REGIONAL REVIEW FINDING

ARC REVIEW CODE: R1903051

Name of Proposal: McCamy Mixed-Use Development (P & L Big Shanty Road) (DRI 2860)

TITLE
DRI PLAN

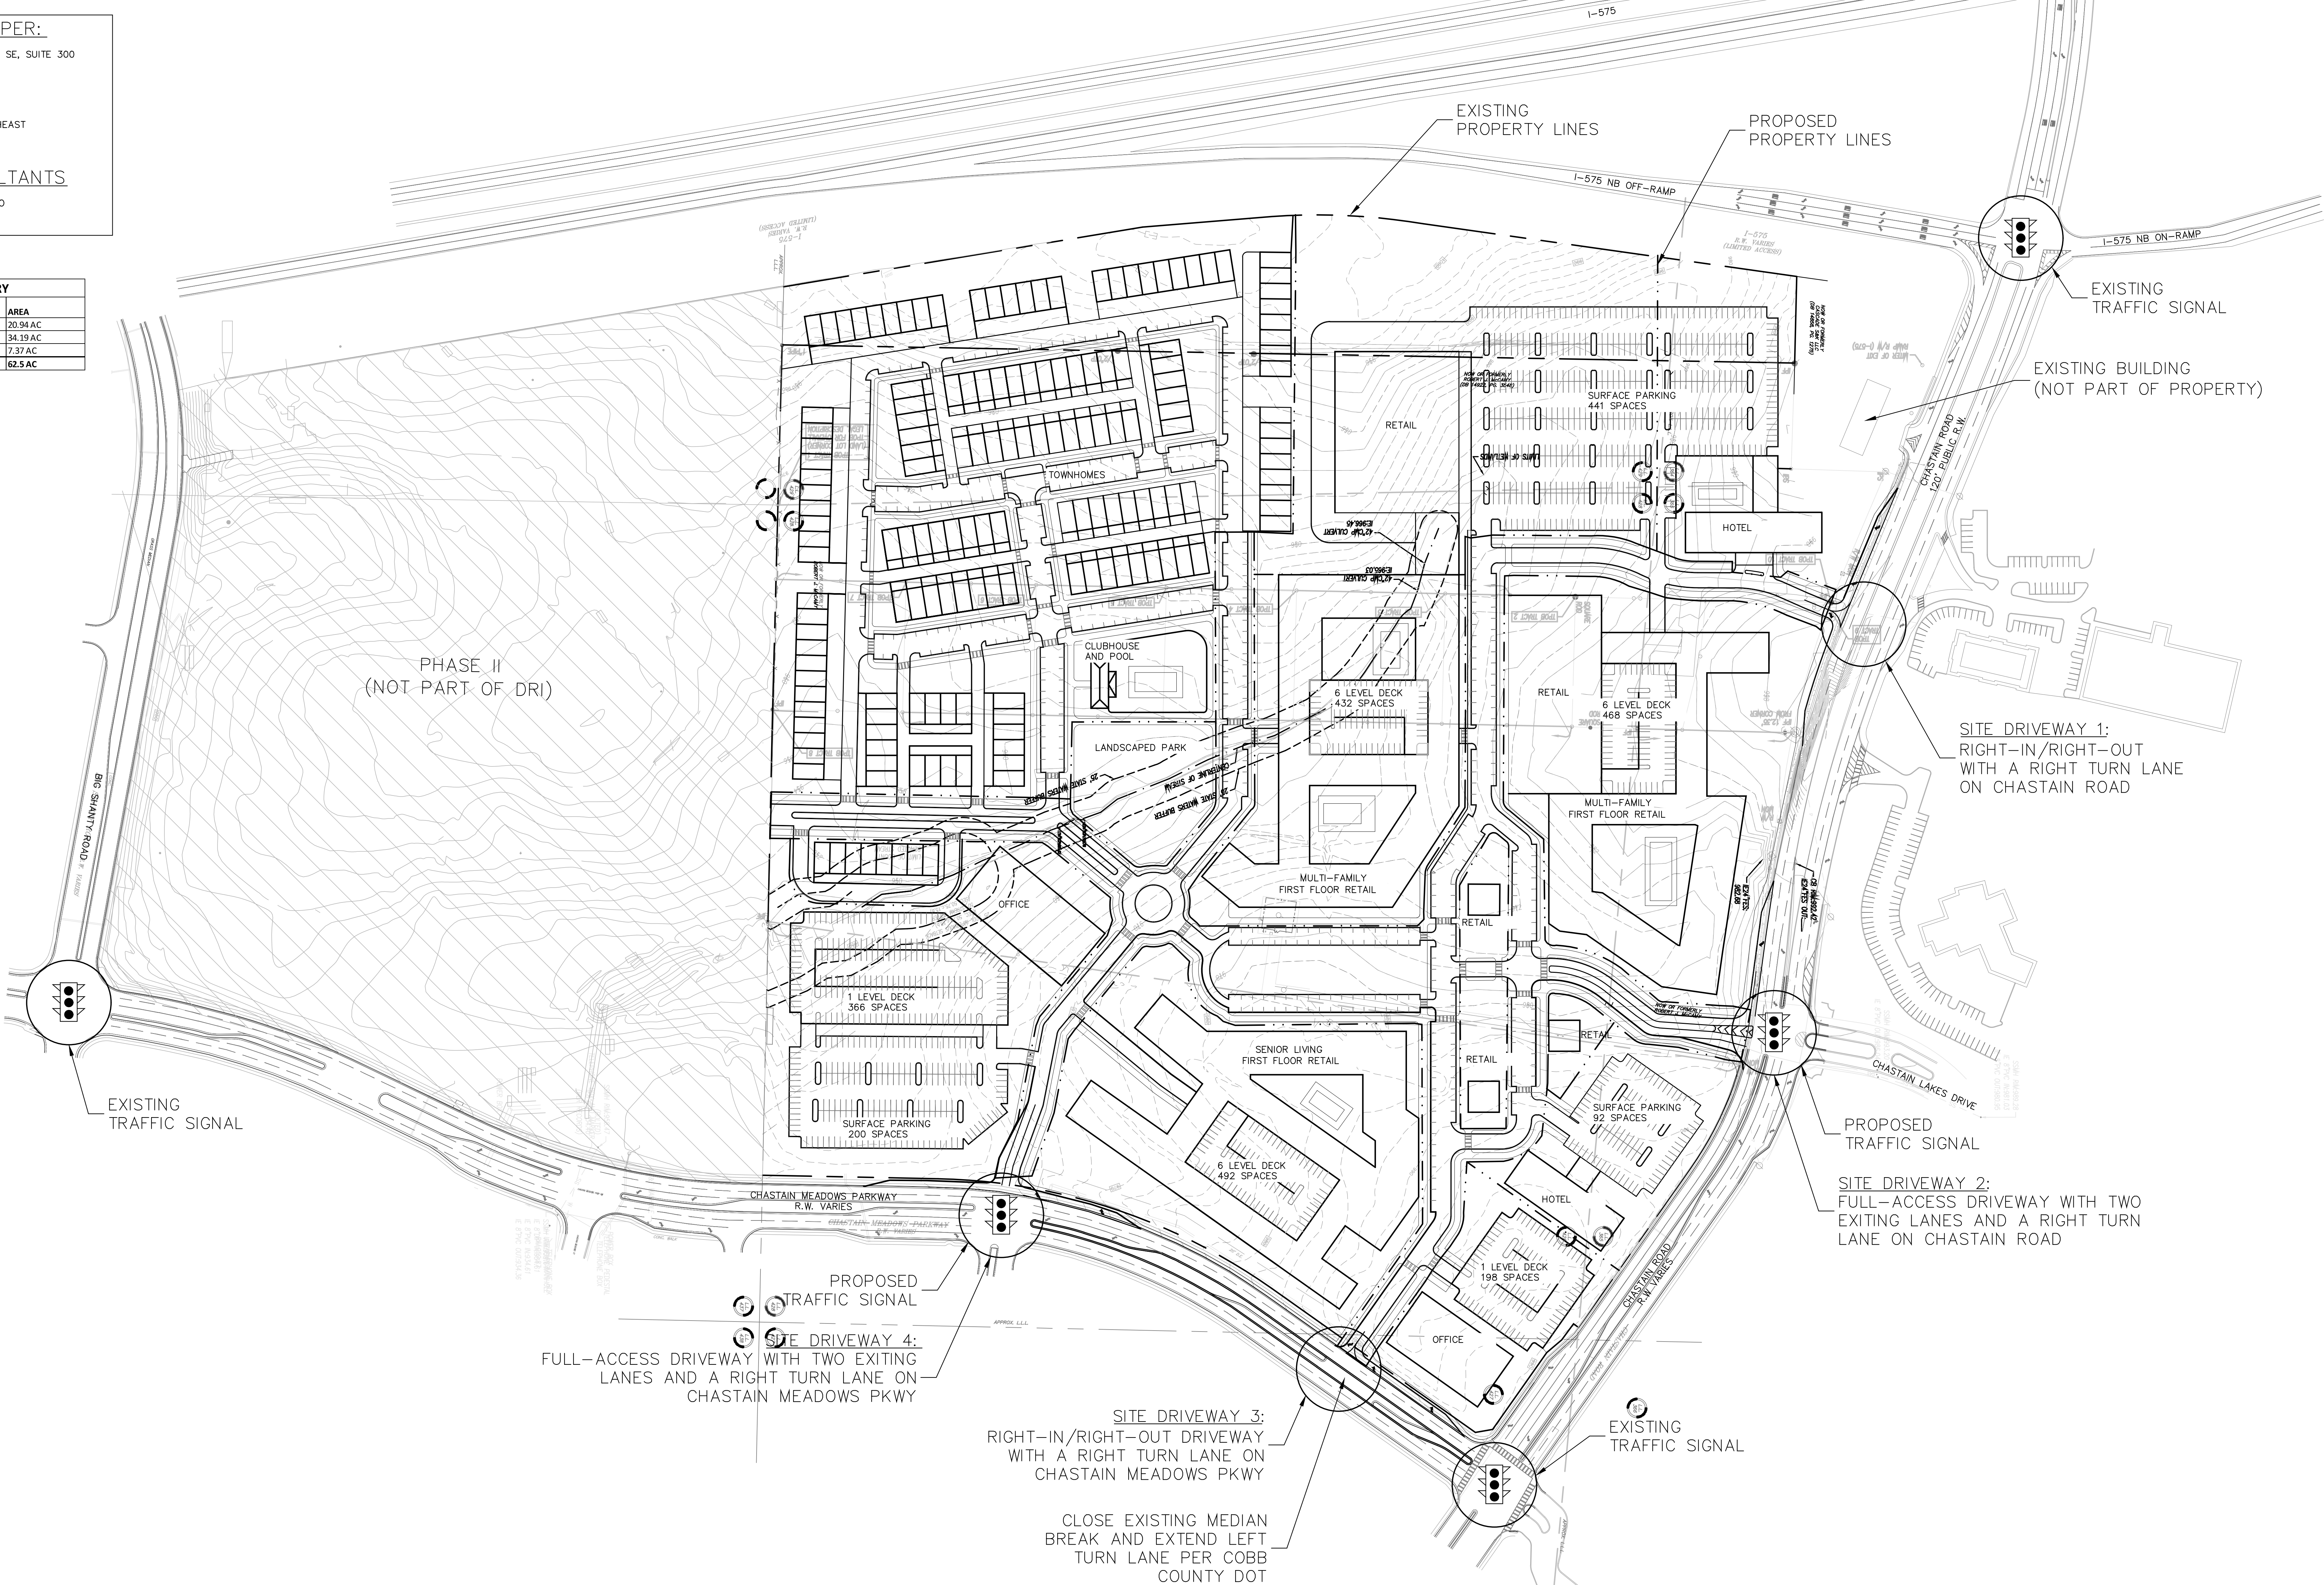
- In terms of the stream that starts in the center of the site, the State 25-foot sediment and erosion buffer is shown on the submitted site plan for most of the stream length. The buffer area widens to an approximately 50-foot/75-foot buffer in roughly the last 400 feet before the property line. The 25-foot State buffer is not shown in this area, and the wider buffers are not identified, but they may indicate the County stream buffers. Much of the stream will be covered by parking, roads and buildings, and the plans show a section that will be culverted. Intrusions into the County buffers may require a variance. Any intrusions into the State sediment and erosion buffer will also require variances. Along those lines, it is worth emphasizing that the Town Center LCI plan contemplates keeping this specific stream daylight or in a more natural condition. The DRI plan diverges from the LCI plan in that regard.

Site plan does depict internal sidewalks. The traffic analysis does not indicate whether bicycle facilities will be constructed internally. Pedestrian and bike facilities currently exist along Chastain Road.

The site plan does not provide specific information or depictions of bicycle and pedestrian facilities, however existing bike ped facilities provide connectivity to adjacent parcels.
